REVIEW OF DETERMINATION ASSESSMENT REPORT

Application Number:	REV2021/0014
----------------------------	--------------

Responsible Officer:	Rebecca Englund
Land to be developed (Address):	Lot 21 DP 11320, 323 - 325 Condamine Street MANLY VALE NSW 2093 Lot 22 DP 11320, 323 - 325 Condamine Street MANLY VALE NSW 2093 Lot 123 DP 737259, 327 - 329 Condamine Street MANLY VALE NSW 2093 Lot 25 DP 11320, 331 Condamine Street MANLY VALE NSW 2093 Lot 20 DP 11320, 321 Condamine Street MANLY VALE NSW 2093
Proposed Development:	Review of Determination of Application DA2020/0824 for demolition works and construction of a shop top housing development and strata subdivision
Zoning:	Warringah LEP2011 - Land zoned B2 Local Centre
Development Permissible:	Yes
Existing Use Rights:	No
Consent Authority:	Northern Beaches Council
Delegation Level:	NBLPP
Land and Environment Court Action:	No
Owner:	Manly Vale Developments No.2 Pty Ltd
Applicant:	Manly Vale Developments No.2 Pty Ltd

Figure 9 - The front setback

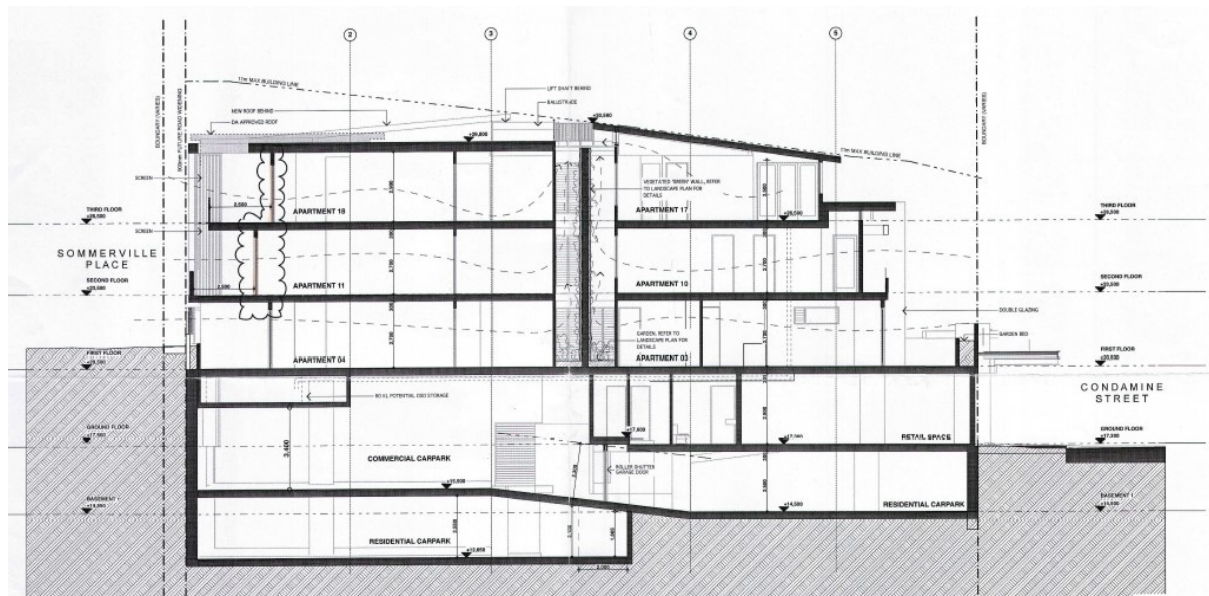
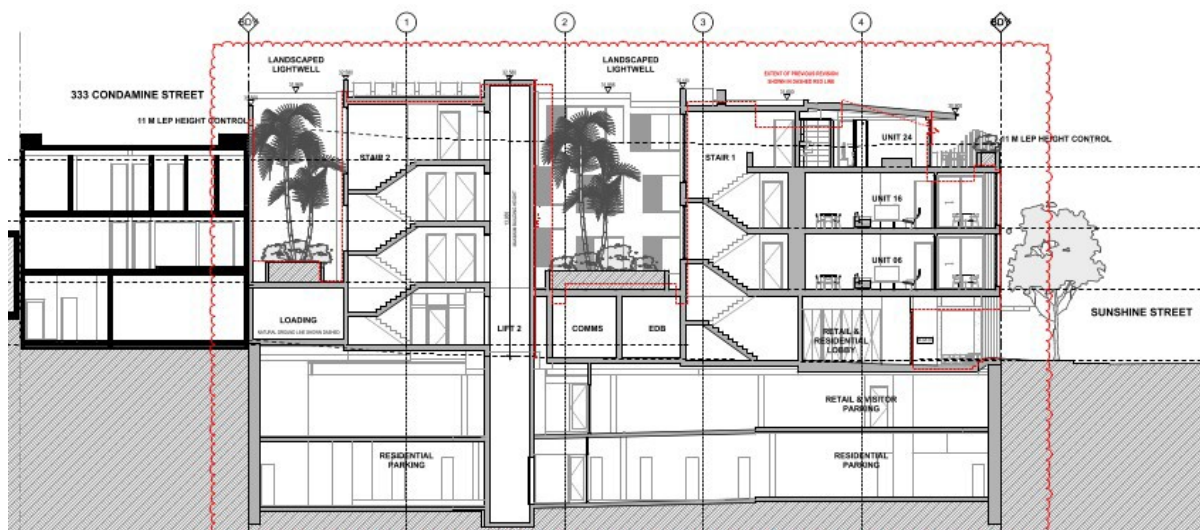
Comment: No other development along this stretch of Condamine Street features nil setbacks to enclosing walls at Level 2, or planters/balustrades associated with Level 3 with nil setbacks to the street. The proposal is inconsistent with the pattern of buildings along both Condamine Street and Sunshine Street. Figures 9 and 10 demonstrate the difference between the setbacks of other development along Condamine Street compared to the setbacks proposed in the subject application.
